Form 504 Ed. June, 1928	
DEPARTMENT OF COMMERCE U. S. COAST AND GEODETIC SURVEY R. S. Patton, Director	
State: Florida	
G. & G. SURVEY L. & A. OCT 27 1930 Acc. No.	
DESCRIPTIVE REPORT	
Topographic Hydrographic	Sheet No. 3 5032
LOCALITY	
Fort Pierce Inlet	
to	
Sebastian Inlet	
to Fort Pierce Inlet	
19 30	
CHIEF OF PARTY	
Charles Shaw

HYDROGRAPHIC TITLE SHEET

Report on Hyd. Sheet No. 5032.

Sebastian Inlet to Fort Pierce Inlet, Florida.

Q' day crossings.

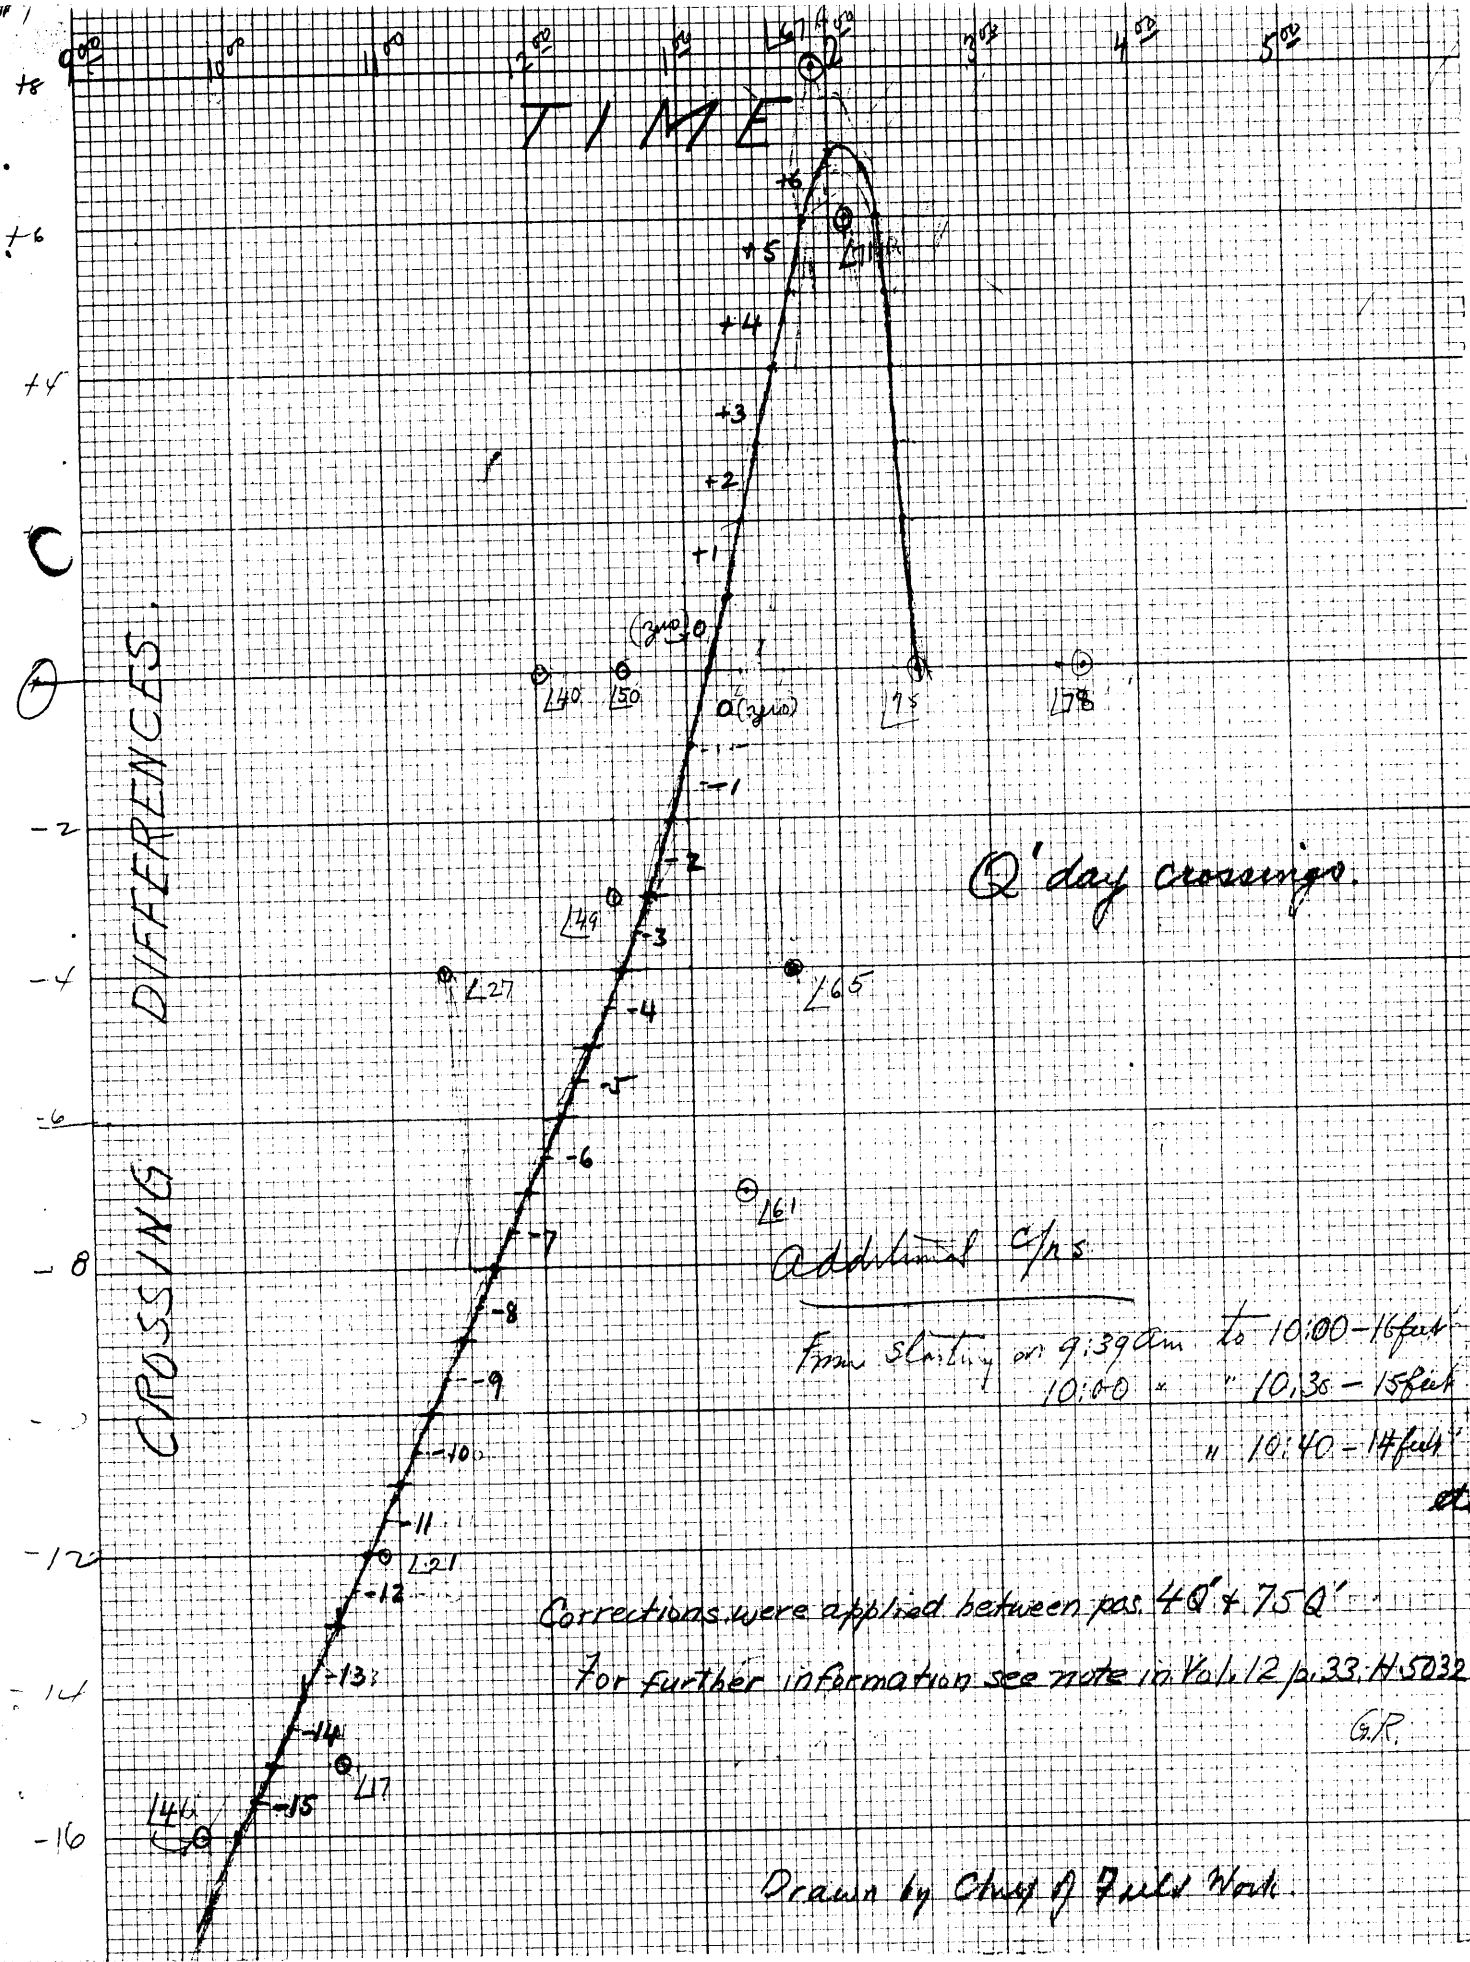
6. There are soundings on Q' day which when plotted make bad crossings with other soundings lines which were considered satisfactory, — location, vicinity of signal "Her" and signal "Ink", lat. $27^{\circ}52'$, long. $80^{\circ}10'$.

A graph drawn by Chief, Section of Field Work, on coordinate paper, attached herewith, with crossing differences as ordinates and ^{their} times as abscissas, beginning with position 4 Q' and ending with 75 Q' day.

Corrections were taken from the resulting graph and applied to the respective soundings, accordingly.

Rather than reject these questionable soundings covering such a large area, it was decided to save them as there are no other soundings in the area affected. The field party can offer no explanation for these discrepancies.

From starting on 9:39 am to 10:00 - 16 feet
 10:00 " " 10:35 - 15 feet
 " 10:40 - 14 feet
 etc

Corrections were applied between pos. 40' + 75 Q'
 For further information see note in Vol. 12 p. 33 H. 5032
